Re: Application for Leave to Construct - EB-2013-0047

System Impact Assessment Report (2nd Addendum)

**Project: Northland Power Solar Martin's Meadows,
Abitibi, Long Lake and Empire**

Document Name	System Impact Assessment Report (Addendum)
Issue	Draft Addendum
Reason for Issue	First Issue
Effective Date	May 20th, 2013

Figure 1: Updated Single Line Diagram

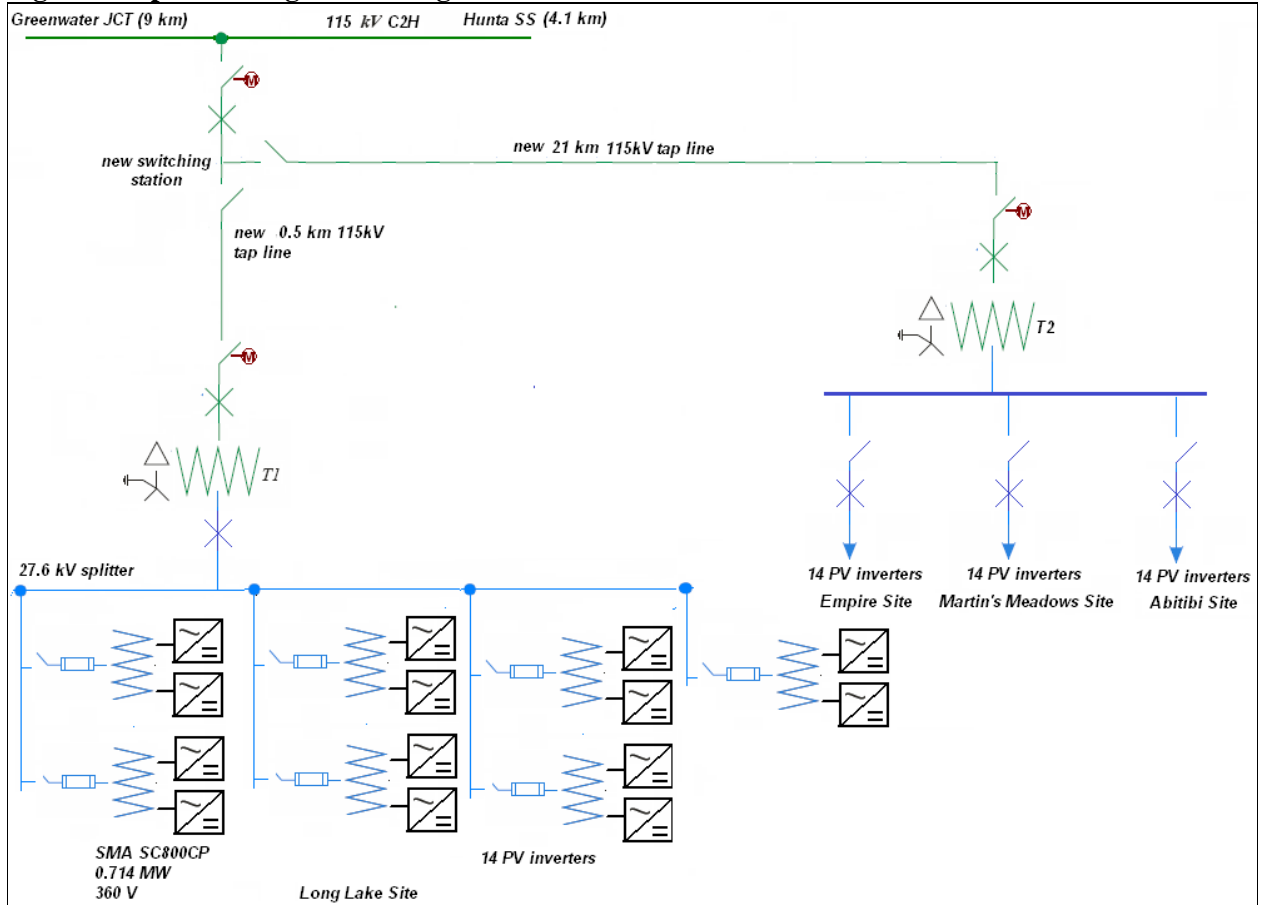
Northland Power (the “connection applicant”) has updated their connection proposal of the Martin’s Meadows, Abitibi and Empire sites to replace their three individual 115-27.6 kV step up transformers with a single higher rated transformer connecting all three sites.

Figure 1 shows an updated single line diagram of the project reflecting the changes identified in this Addendum.

The IESO and Hydro One have examined the proposed change and concluded that it is not materially different from the first Addendum’s application data, as the equivalent impedance of the new transformer is similar to that of the three single transformers previously assessed.

The IESO recommends that a *Notification of Conditional Approval for Connection* be issued for the proposed connection of Northland Power Solar Long Lake, Abitibi, Martin’s Meadows and Empire, operating up to 40MW, subject to implementation of the requirements outlined in the previous SIA reports.
